# CITY OF MILWAUKIE

## AGENDA

January 3, 2022

**Subject:** **Master File:** VR-2021-017  
**Applicant/Owner:** SODO, LLC  
**Applicant's Representative:** Jessamyn Griffin, Works Progress Architecture  
**Address:** 2206 SE Washington St  
**Legal Description (Map & Tax Lots):** 11E36BC01700  
**NDA(s):** Historic Milwaukie

Figure 3. Zoning

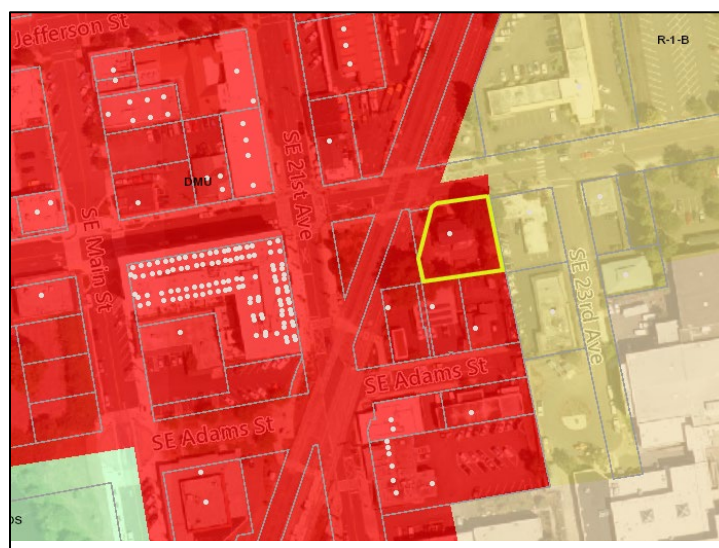
**B. Zoning Designation** (see Figure 3)

The site is at the eastern edge of Milwaukie's downtown area, with the R-1-B zone directly to the east.
